[Docket No. FAA–2009–0218; Directorate Identifier 2009–CE–006–AD]

Airworthiness Directives; Piper Aircraft, Inc. PA–23, PA–31, and PA–42 Airplanes

ACTION: Notice of proposed rulemaking (NPRM).

Figure 1. – Nose Baggage Door Placard.

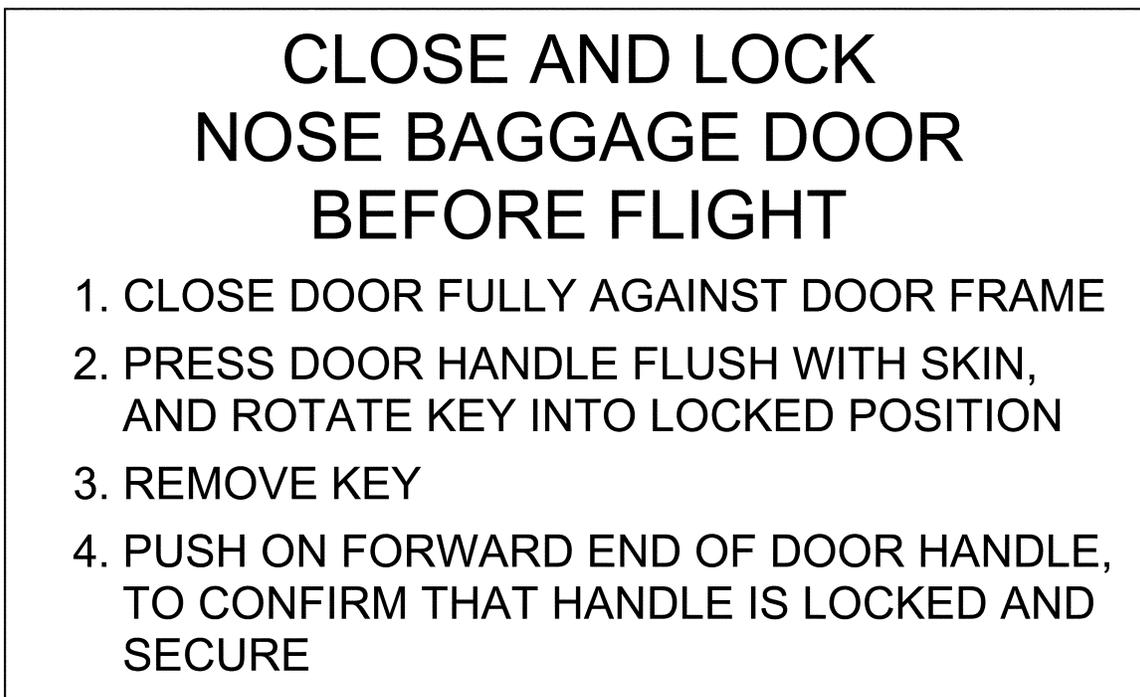
<p>(2) For all aircraft:</p> <ul style="list-style-type: none"> (i) Lubricate and inspect all nose baggage door latching and locking components for damaged, worn, corroded, or non-conforming components; and (ii) Verify the key can only be removed from the lock assembly in the locked position in accordance with the service instructions. 	<p>Initially within 100 hours TIS after July 24, 2009 (the effective date retained from AD 2009-13-06); and Repetitively thereafter at intervals not to exceed 100 hours TIS.</p>	<p>Follow INSTRUCTIONS: PART II of Piper Aircraft, Inc. Mandatory Service Bulletin No. 1194A, dated November 10, 2008.</p>
<p>(3) For all aircraft with damaged, worn, corroded, or non-conforming components: repair/replace any damaged, worn, corroded, or non-conforming components.</p>	<p>Before further flight after any inspection required in paragraphs (f)(1) and (f)(2) of this AD where any evidence of damaged, worn, corroded or non-conforming components was found.</p>	<p>Follow Piper Aircraft, Inc. Mandatory Service Bulletin No. 1194A, dated November 10, 2008.</p>
